AGENDA
CONCEPTUAL PLAN REVIEW COMMITTEE
Community Room, 3rd Floor
Arlington Heights Village Hall, 33 S. Arlington Heights Rd.
Arlington Heights IL 60005
December 18, 2024
6:00 PM

VILLAGE OF ARLINGTON HEIGHTS **STAFF DEVELOPMENT** **COMMITTEE REPORT**

Temp File Number: T1849
Project Title: 1515 S Douglas Ave
 Subdivision
Address: 1515 S Douglas Ave
PIN: 08-103-01-018-0000

To: Conceptual Plan Review Committee
Prepared By: Dan Osoba, Planner I
Meeting Date: December 18, 2024
Date Prepared: December 10, 2024

PROPOSED GEOMETRIC & UTILITY PLAN	
1515 S. DOUGLAS AVE, ARLINGTON HEIGHTS, IL	
JOB NO.:	24-23
DESIGN BY:	KU
DRAWN BY:	KU
SCALE:	1\" = 20'
2 OF 5

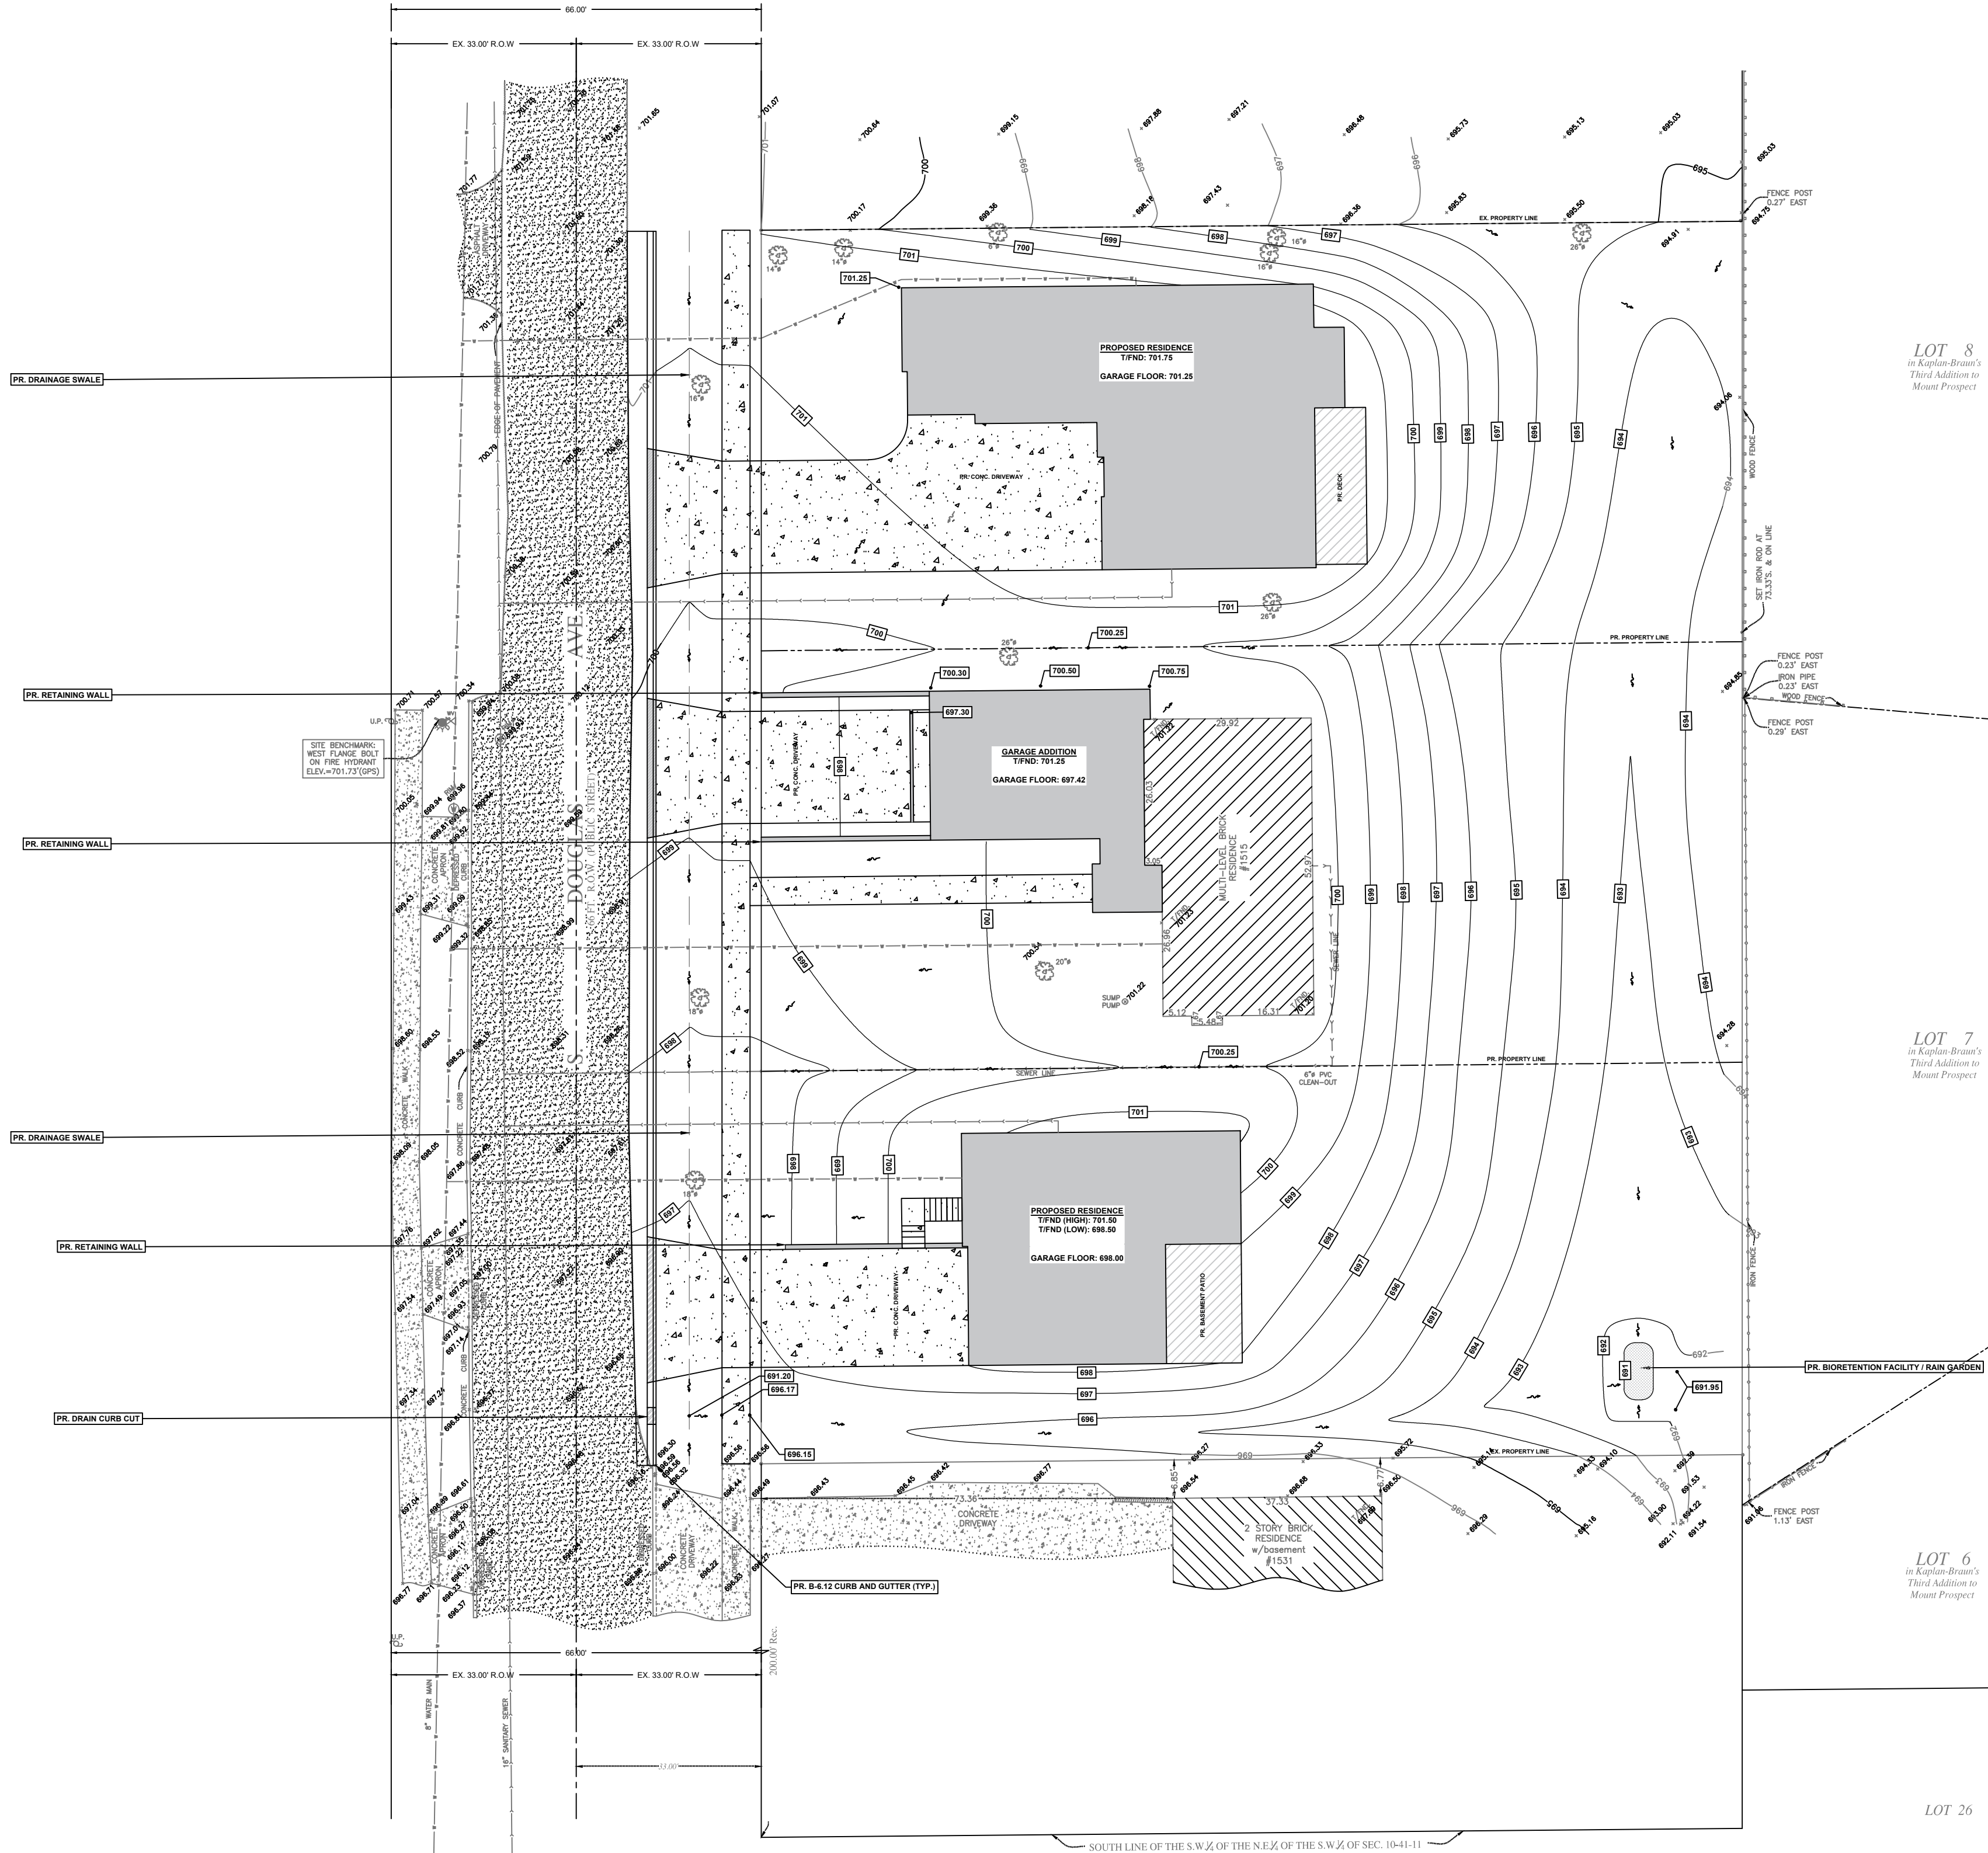
Public improvements for this development include widening of the east side of S. Douglas Avenue, including curb and gutter, public sidewalk, street lighting, and storm sewer improvements. Prior to the Final Plat being brought before Village Board approval, a Public Improvement Deposit or Letter of Credit based on the estimated public construction cost. The petitioner shall coordinate with staff to determine this cost during formal Plan Commission review.

Village staff has indicated that money-in-lieu of detention would be acceptable for this proposal; however, the property does abut single-family homes to the east that are located in Mount Prospect. The existing drainage flows from west to east. The petitioner has coordinated with Engineering staff at the Village of Mount Prospect (see the attached Correspondence exhibit on this agenda item). Mount Prospect staff recommended grading the site so drainage flows from east to west and to provide a small berm and rain garden in the southwest corners of the lots to try to intercept and slow down the off-site flows. The proposed grading plan will be evaluated during the formal Plan Commission process to ensure downstream conditions would not be affected.

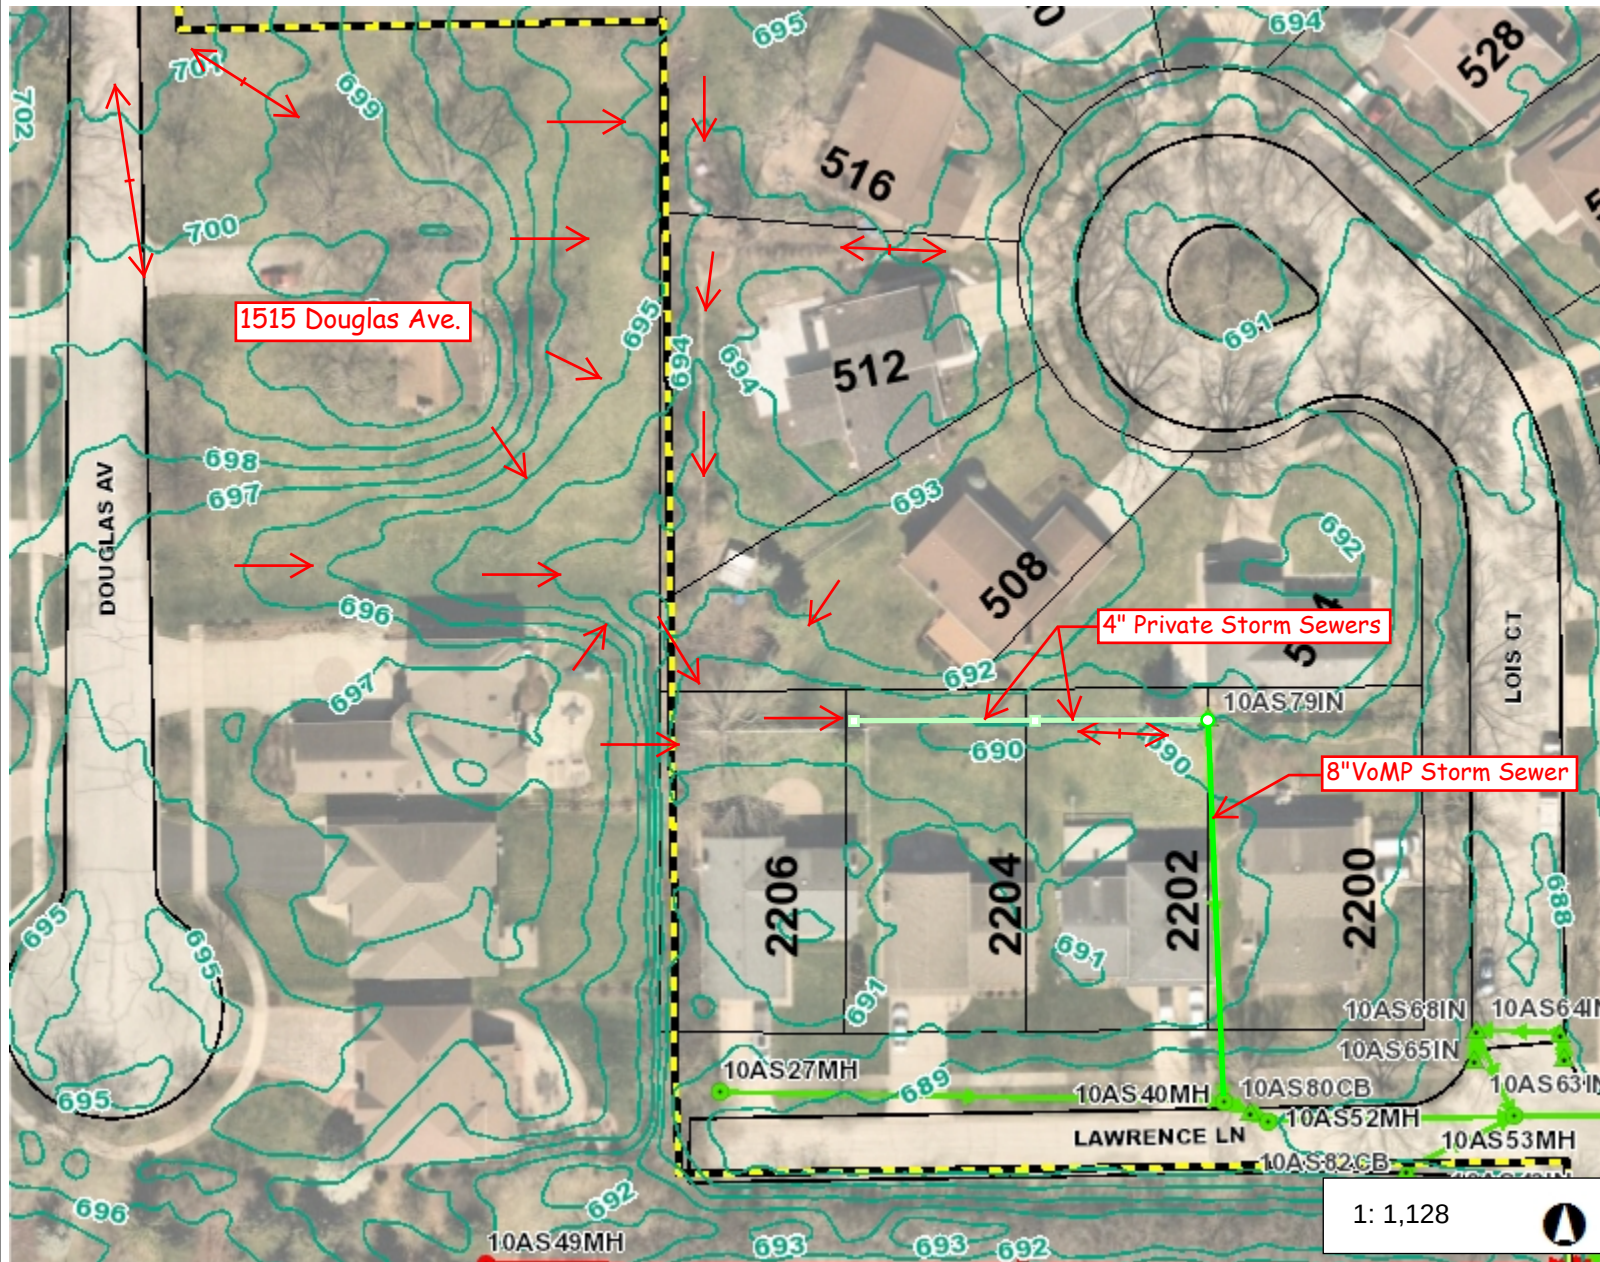
My name is Chuck Lindelof; I am a project engineer with the Village of Mount Prospect. Matt & I looked over the preliminary plans and offer the following:

318 E. EMERSON St. - Arlington Heights, Ill.
Proposed Site Plan

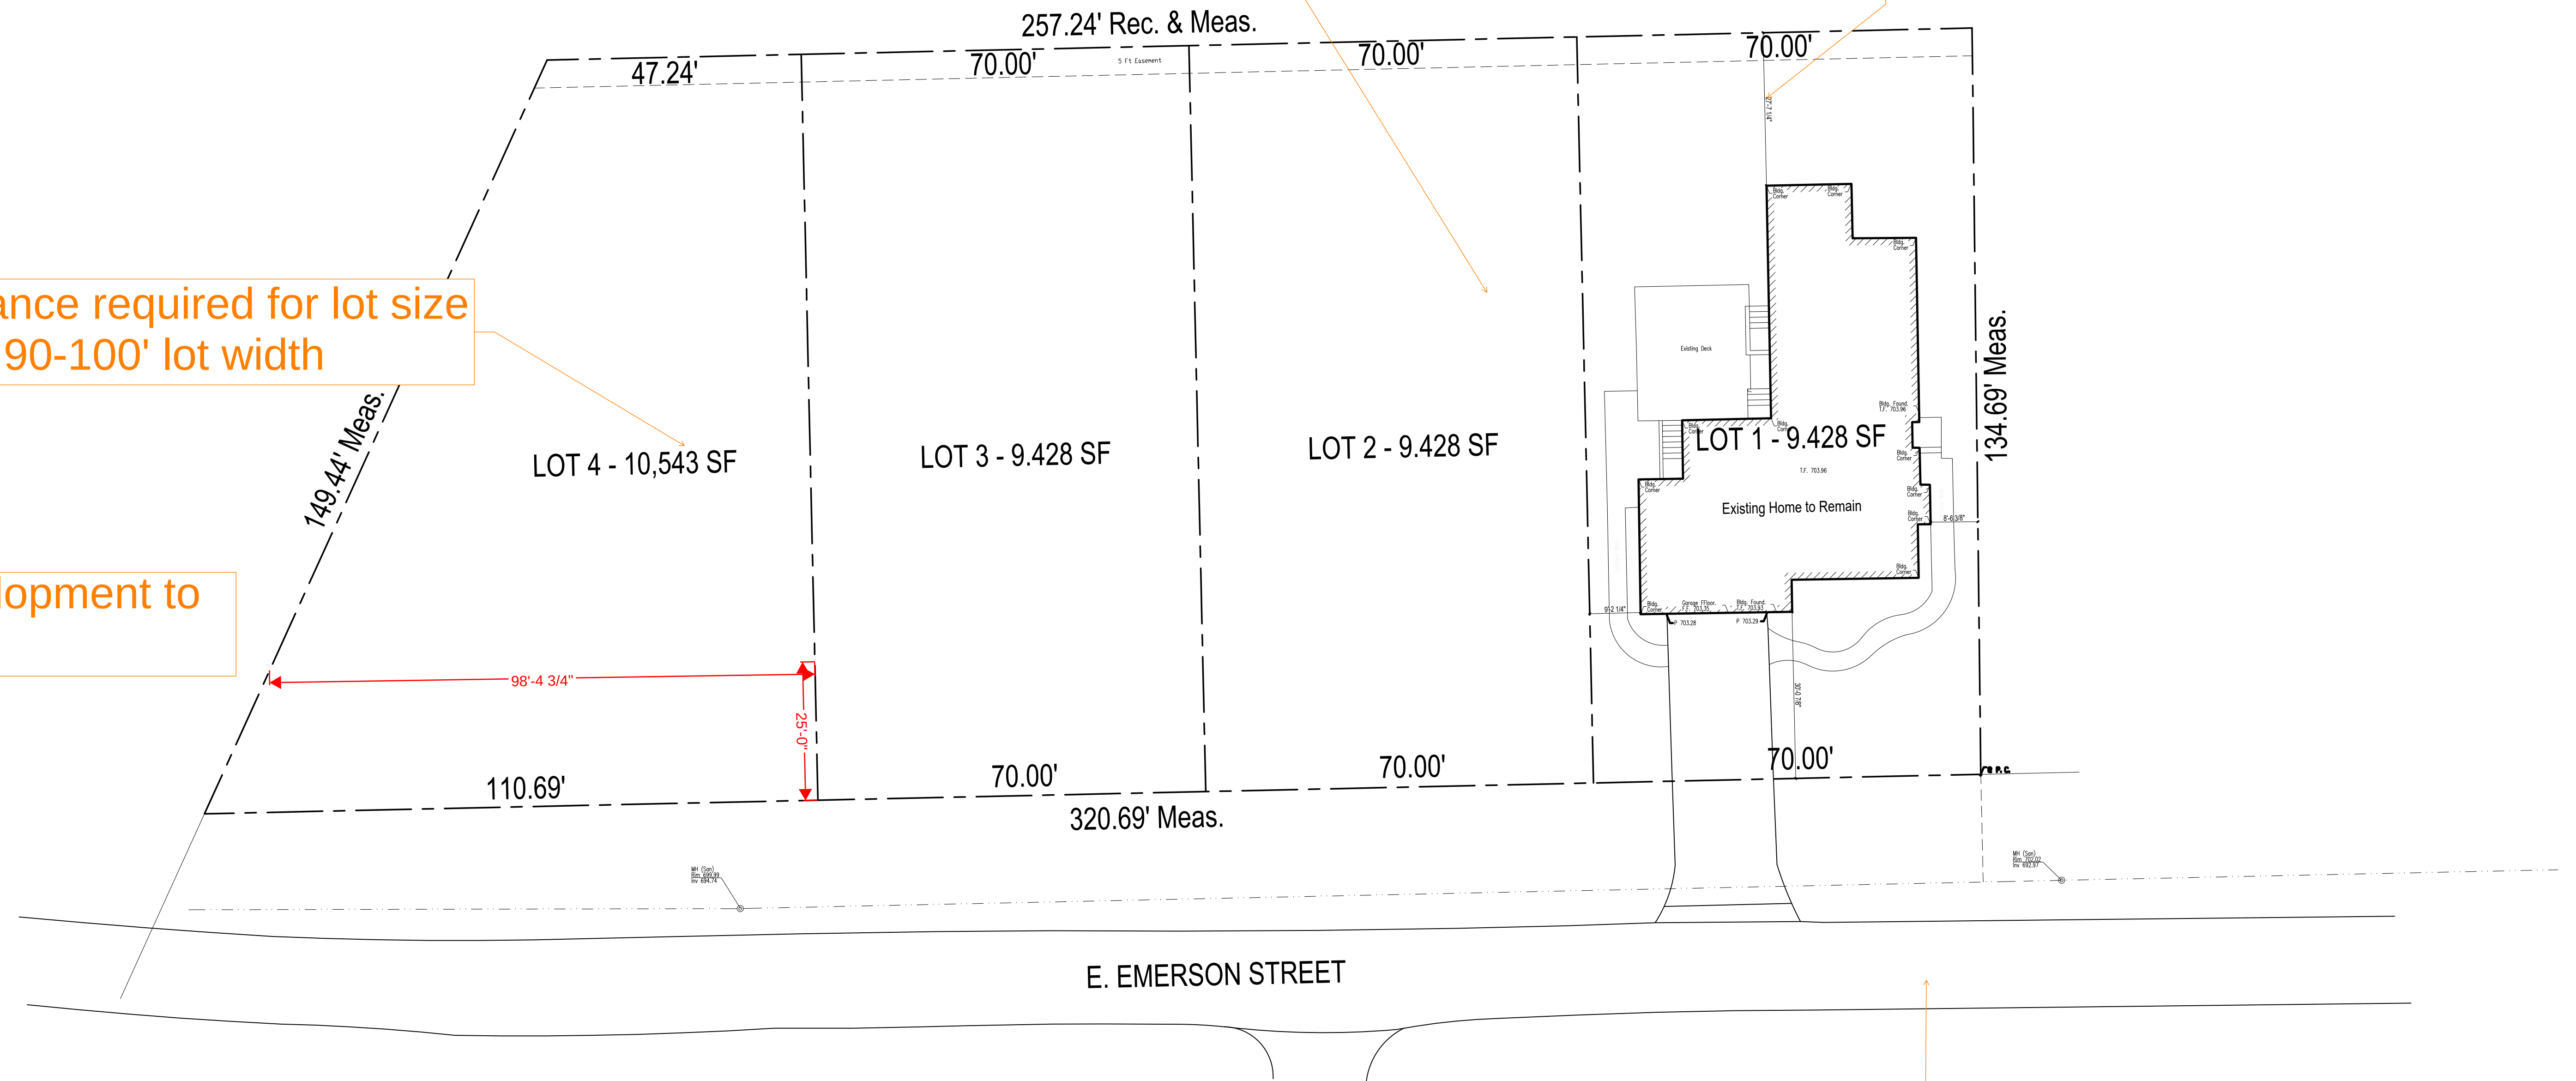
As a four-lot subdivision, one lot is required to be reserved for onsite detention. The petitioner will need to conform to all applicable Village and Metropolitan Water Reclamation District (MWRD) regulations relative to stormwater, and detention calculations shall be required as part of the Plan Commission application.

The SDC is generally supportive of the application, but would recommend a three-lot subdivision to better align with the neighboring properties. The applicant will need to address following:
